SUBJECT: CALVERT CLIFFS NUCLEAR POWER PLANT, UNIT NOS. 1 AND 2 -
REQUEST FOR ADDITIONAL INFORMATION REGARDING
IMPLEMENTATION OF ALTERNATIVE SOURCE TERM (TAC NOS. MC8845
AND MC8846)

REQUEST FOR ADDITIONAL INFORMATION

IMPLEMENTATION OF ALTERNATIVE SOURCE TERM

CALVERT CLIFFS NUCLEAR POWER PLANT, UNIT NOS. 1 AND 2

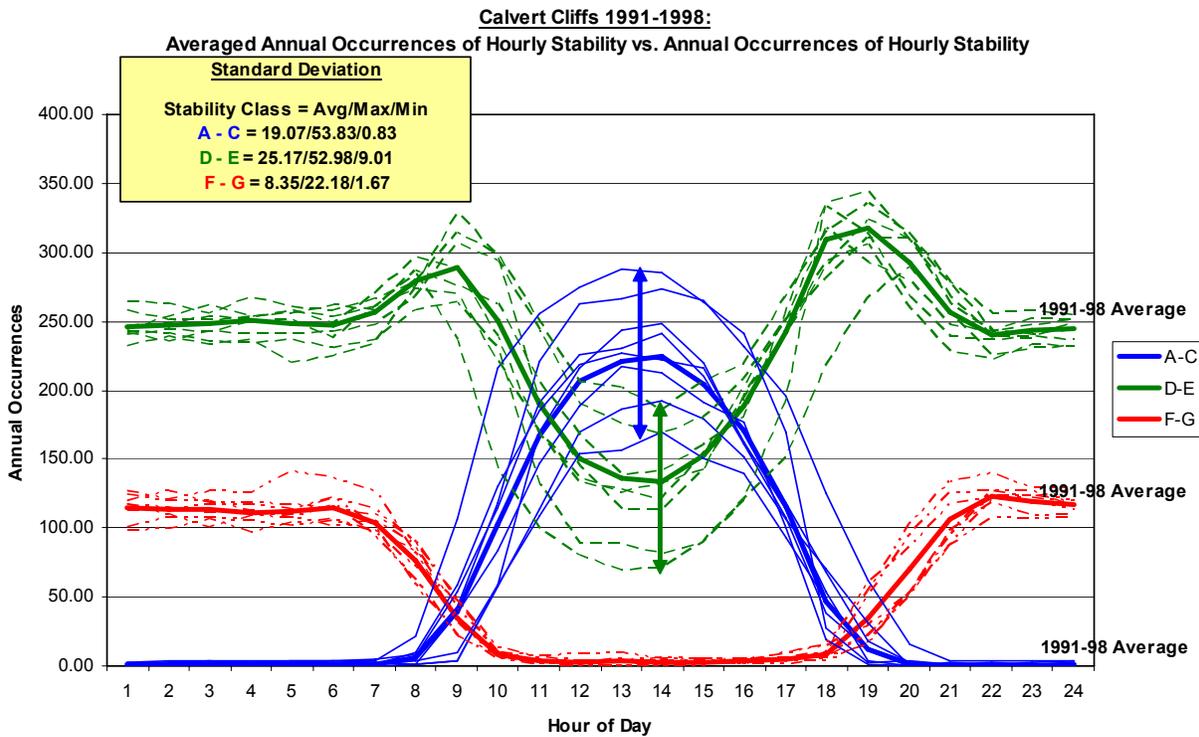
The NRC staff performed confirmatory analysis of the hourly atmospheric stability values provided and noticed some variations relative to the distributions for certain classes. If the stability classes A thru G are combined to form only three different class groups: Unstable (A-C), Neutral (D-E), and Stable (F-G), the variance becomes apparent. The above figure is a composite view of each year's hourly stability annual occurrences and their variation from the annual mean for all 8 years combined (1991 - 1998):

1. In the figure, it shows that unstable stability classes A-C have an average standard deviation of 19.07, a maximum of 53.83, and a minimum of 0.83. Neutral stability classes D-E have an average of 25.17, a maximum of 52.98, and a minimum of 9.01. Stable stability classes F-G were the most behaved data with an average standard

deviation of 8.35, a maximum of 22.18, and a minimum of 1.67. Given the uncertainty in the data, justify why annual calculations of atmospheric dispersion factors (χ/Q values) should not be performed independently (each year separately) providing the most conservative resulting values listed for accidental atmospheric releases.
